U.S. Department of Energy  
**Office of River Protection**

04-WTP-268

U.S. DEPARTMENT OF ENERGY (DOE), OFFICE OF RIVER PROTECTION (ORP)  
RESPONSES TO THE DEFENSE NUCLEAR FACILITIES SAFETY BOARD (DNFSB)  
CONCERNS

## **Responses to Issues Raised in July 21, 2004 Defense Nuclear Facilities Safety Board (DNFSB) Letter Regarding Waste Treatment and Immobilization Plant (WTP) Ventilation Systems Design**

# RPP-WTP Pretreatment Facility ISRS

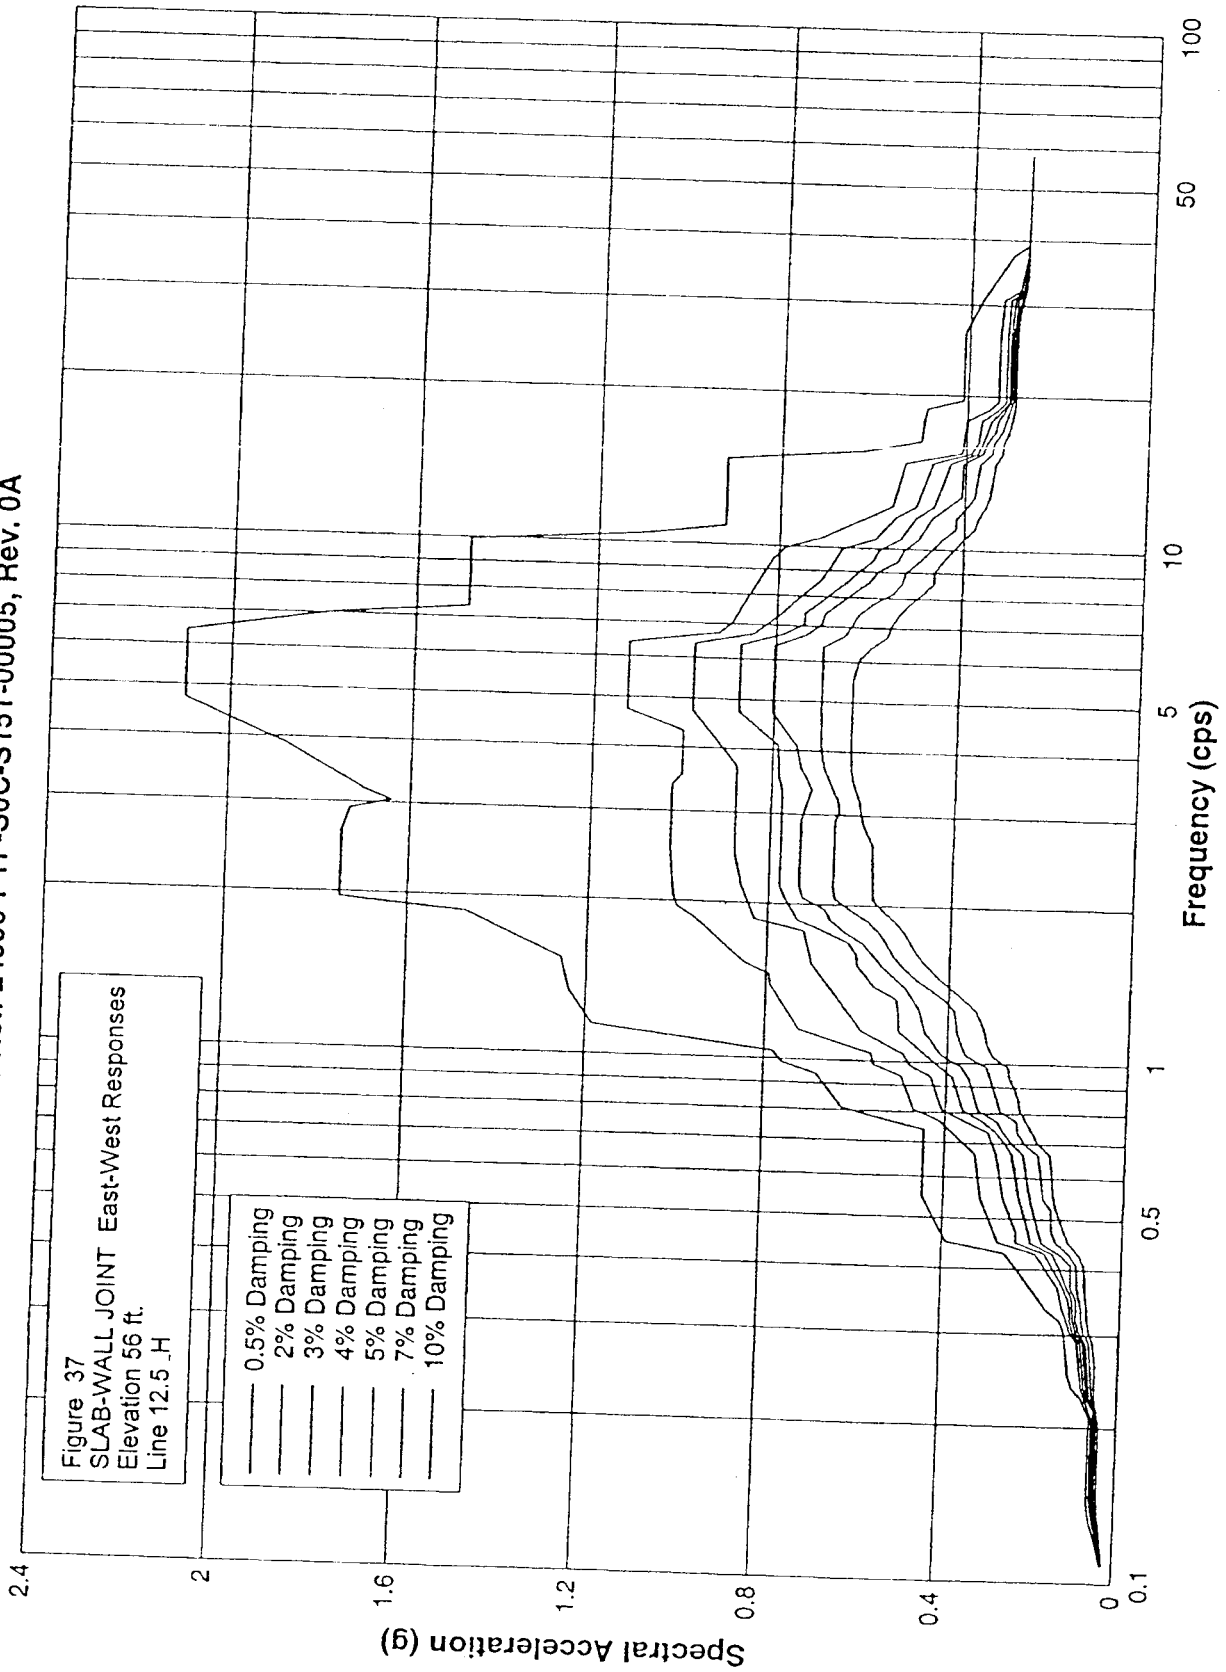
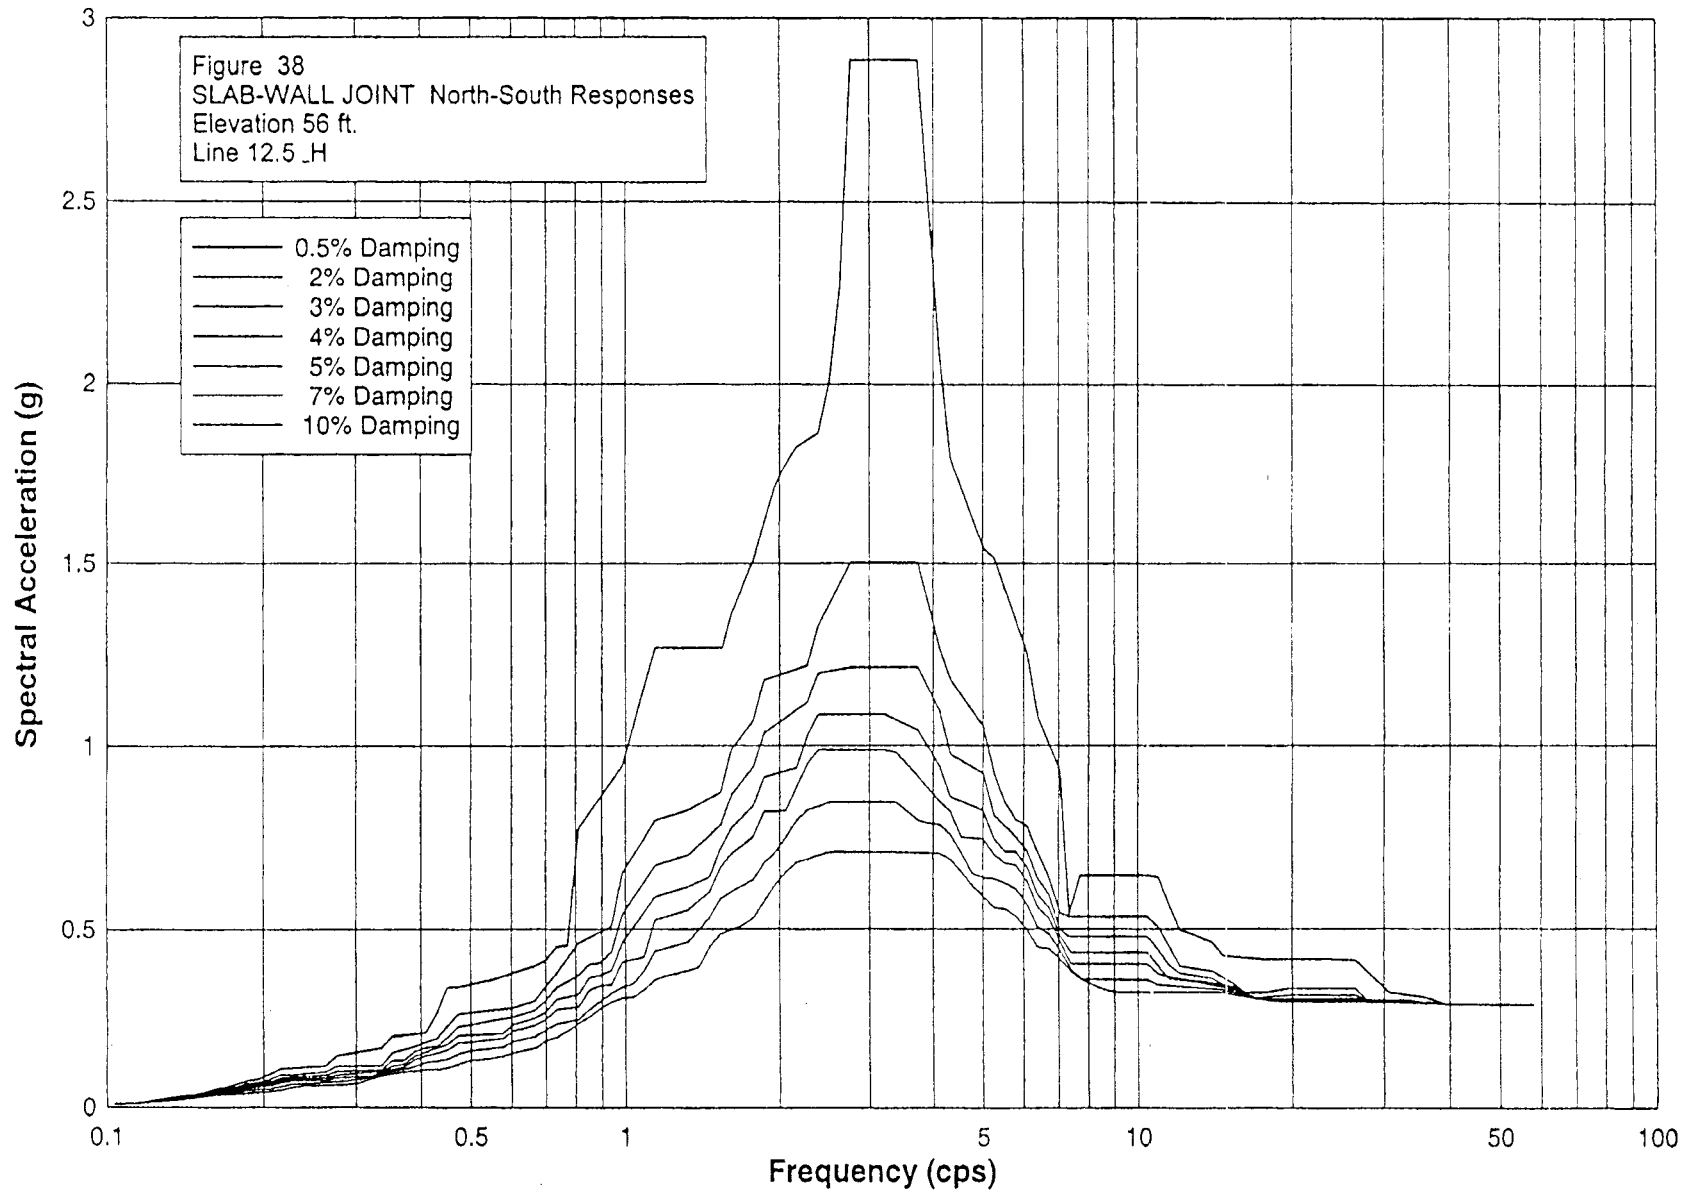
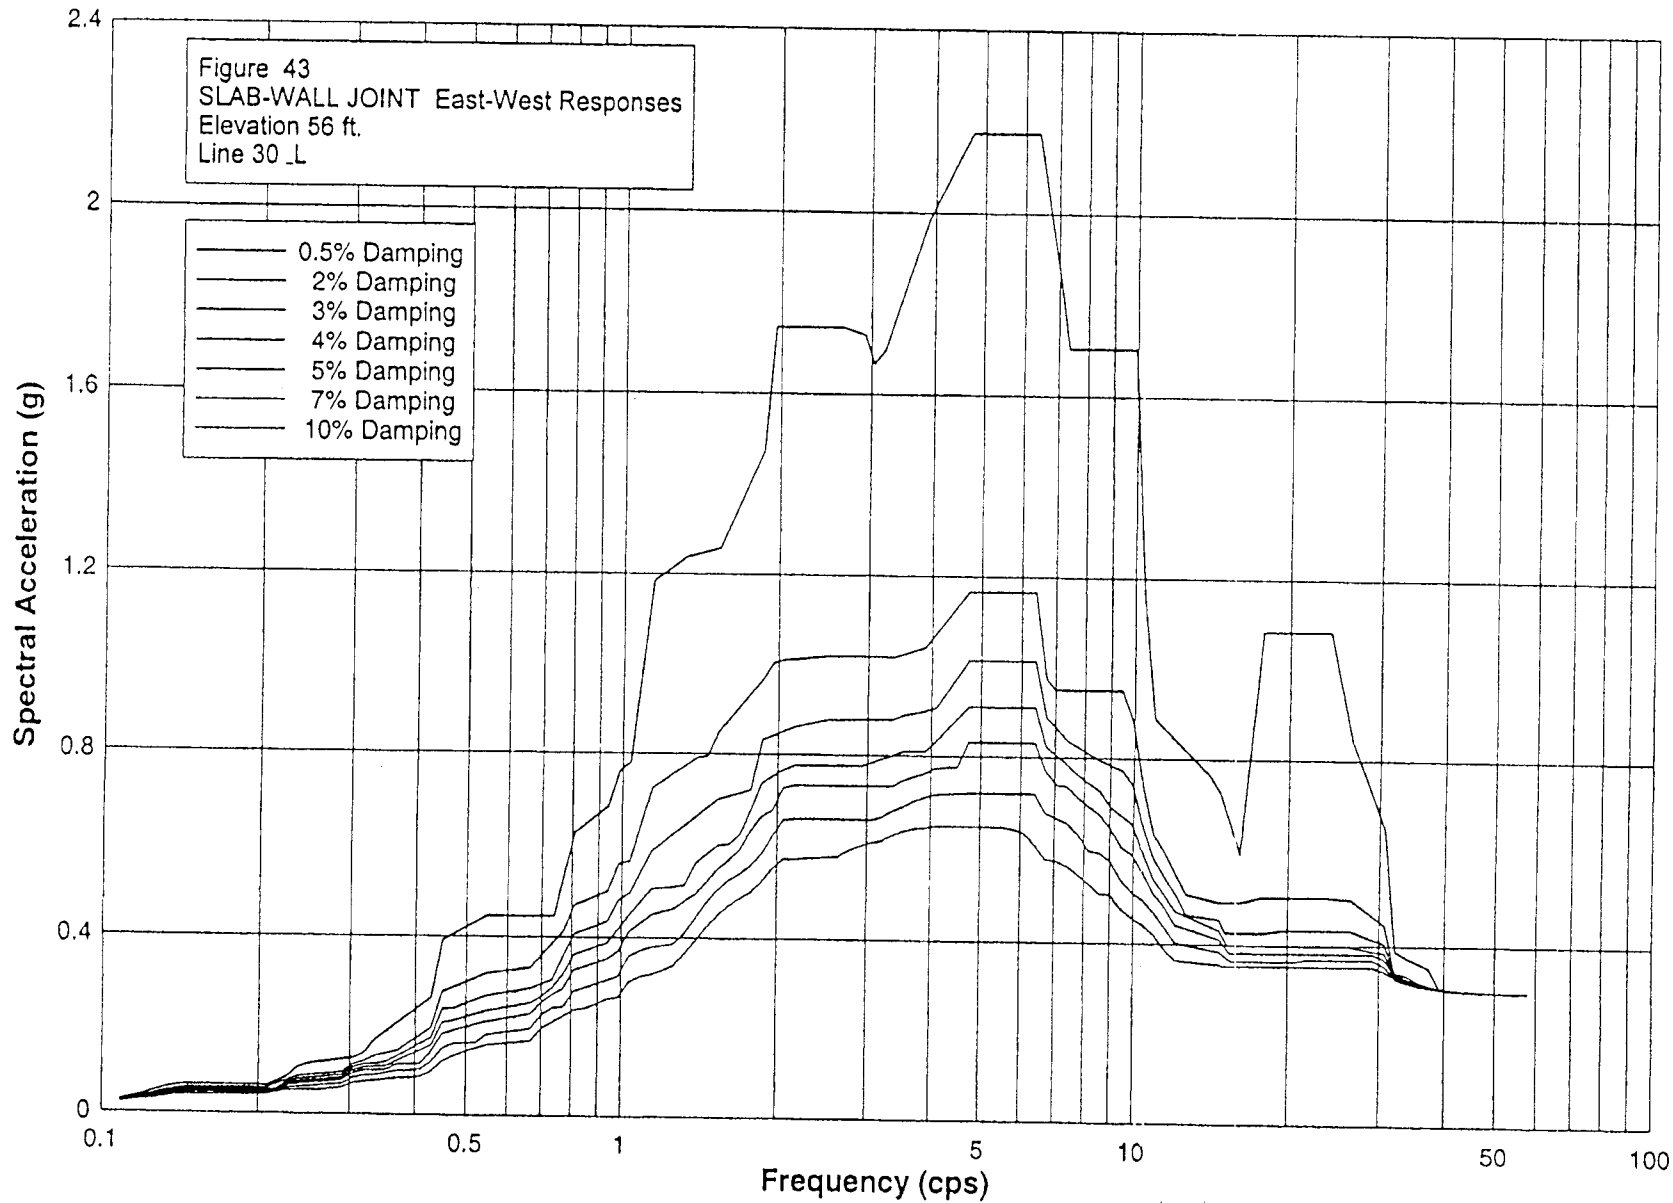
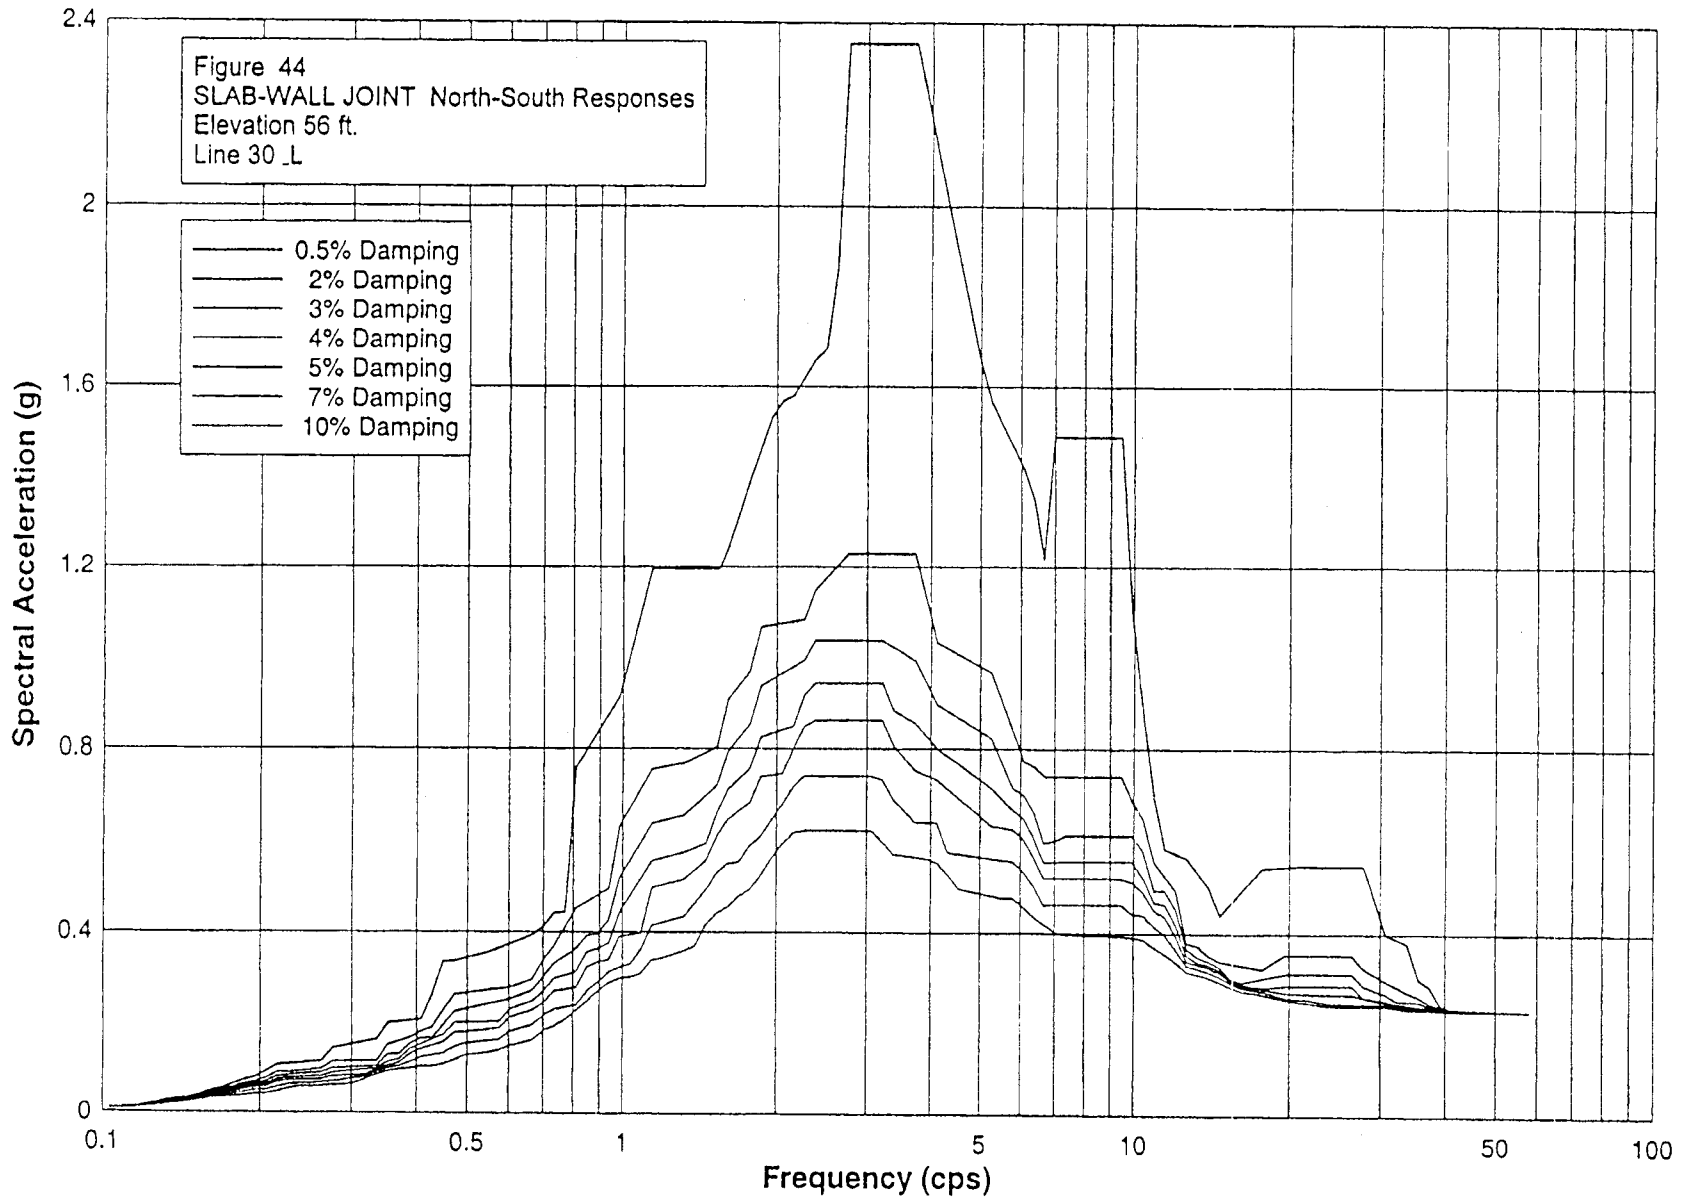
**WTP-04-281-02** The planned ventilation filter housing shaker table tests will use a bounding seismic spectra as input for the shaker table tests. The staff wants to review the bounding data for suitability.

**Response:** The WTP Project will not use bounding data for the PT and HLW facilities. The specific In-Structure Response Spectra (ISRS) curves for each facility will be used and separate testing for each facility will be conducted. The applicable curves, by elevation and column line, for the Remote Change HEPA Filter housings will be used which shows the expected frequencies and accelerations in the north/south, east/west, and vertical directions. The reason for applying the ISRS curves specific to each building and not using bounding data is as follows:

The Remote Change HEPA Filter Housings in the PT and HLW buildings will require separate testing for the following reasons:

- a) The housings are supported by steel platforms. Since the platforms are not rigid, they need to be simulated for testing. The platform configurations are different. Therefore, their simulations would be different, requiring separate testing.
- b) ISRS for PT and HLW buildings are different.
- c) It is likely that the external loads on the housings, e.g., connected ducts, in PT could be different from those in HLW.

Enclosed are the ISRS curves applicable to the Remote Change HEPA Filter housings in the HLW and PTF facilities.†
